SUNDRY NOTICES AND REPORTS ON WELLS (DO NOT USE THIS FORM FOR PROPOSALS TO DRILL OR TO DEEPEN OR PLUG BACK TO A DIFFERENT RESERVOIR. USE "APPLICATION FOR PERMIT" (FORM C-101) FOR SUCH PROPOSALS.)		WELL API NO. 30-015-40890

2. Name of Operator OXY USA Inc.		6. State Oil & Gas Lease No. UG-3604-0062
3. Address of Operator P.O. Box 50250 Midland, TX 79710		7. Lease Name or Unit Agreement Name Lost Tank 35 State SWD

SUMMARY OF CHANGES:

Lost Tank 35 St SWD 1 - Forward Plan

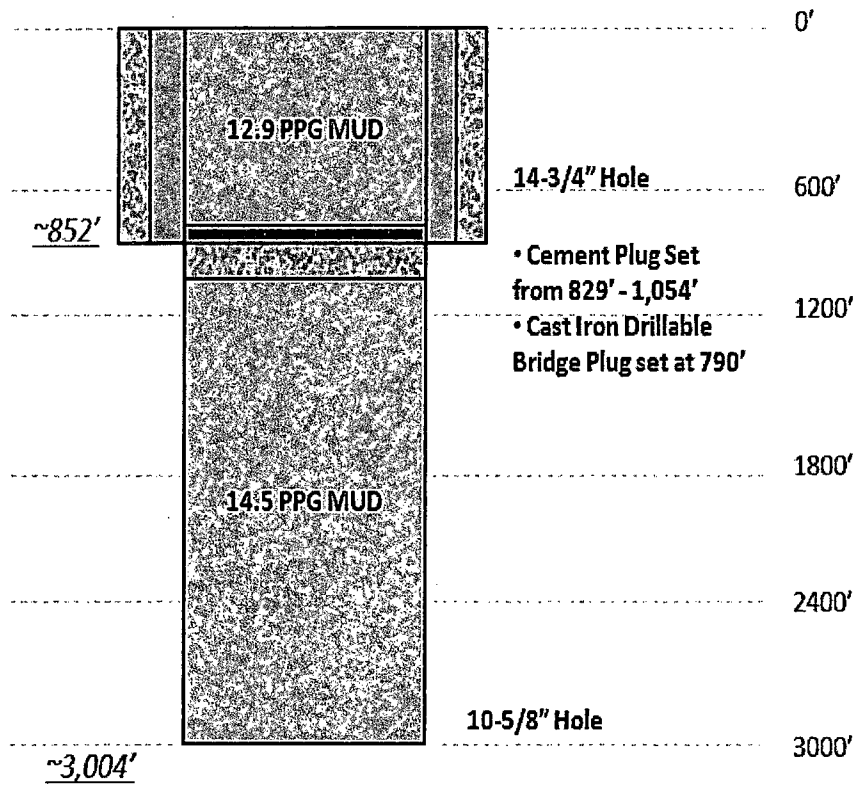
Option 1 – Flex 3 using same wellbore (3 string if able to contain flow with casing drilling)

- Expand location for a Flex 3 w/ enough space for at least 5 additional frac tanks.
- Drill out CIBP and cement. If no losses/gains with the kill mud weight in the hole, casing drill 10 5/8" hole to ~4340' (100' into Lamar) and cement 9 5/8" 40# J55 UFJ casing. Drill 8 3/4" hole to TD of ~6320' and set 7" 26# L80 LTC casing.

Option 2 – Flex 3 using same wellbore (4 string if unable to contain flow with casing drilling)

- Expand location for a Flex 3 w/ enough space for at least 5 additional frac tanks.
- Drill out CIBP and cement. Casing drill 10 5/8" hole to ~3200' and cement 9 5/8" 40# J55 UFJ casing to isolate flow, in the scenario where losses are experienced with the 14 ppg mud, or if H2S levels raise above the HES limits. Drill 8 3/4" hole to ~ 4340' (100' into Lamar) and set 7 5/8" 26.4# J55 UFJ casing. Drill 6 3/4" hole to TD of ~6320' and set 5 1/2" 17# L80 BTC casing.

Option #1

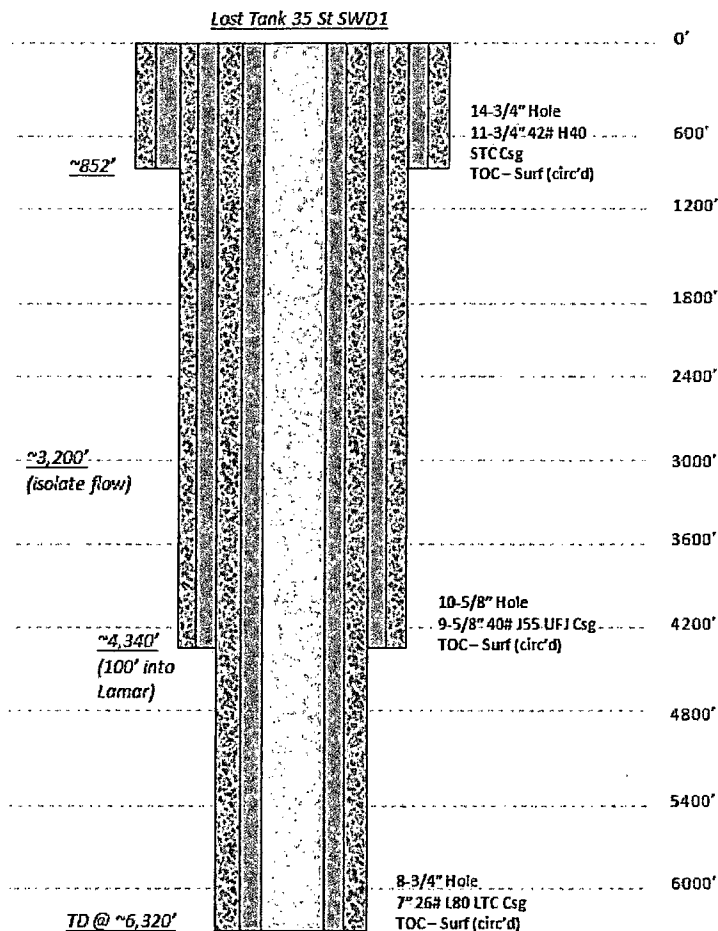
If able to control flow with casing drilling:

- Casing design
 - 9 5/8" 40# J55 ULT-FJ
 - 7" 26# L80 LTC
- Wellhead
 - Cameron MBS
- Centralizers/Float Equipment
 - Davis-Lynch
 - 9 5/8" FE available (oxy owned)
 - Wear Sox Centralizers
- Expand location
- Drill mousehole

Option #2

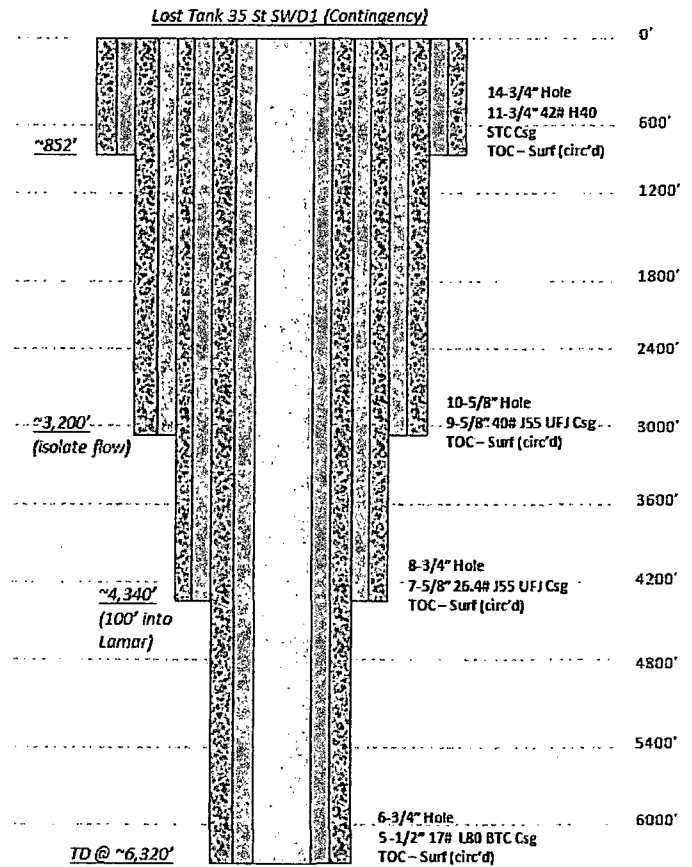
If unable to control flow with casing drilling:

- Casing design
 - 9 5/8" 40# J55 ULT-FJ
 - 7 5/8" 26.4# J55 ULT-FJ
 - 5 1/2" 17# L80 BTC
- Wellhead
 - Cameron MBS
- Centralizers/Float Equipment
 - Davis-Lynch
 - 9 5/8" Float Eq available (oxy owned)
 - Wear Sox Centralizers
 - Weatherford
 - 7 5/8" Float Eq
(Currently being thread for Ult-FJ)
- Expand location
- Drill mousehole
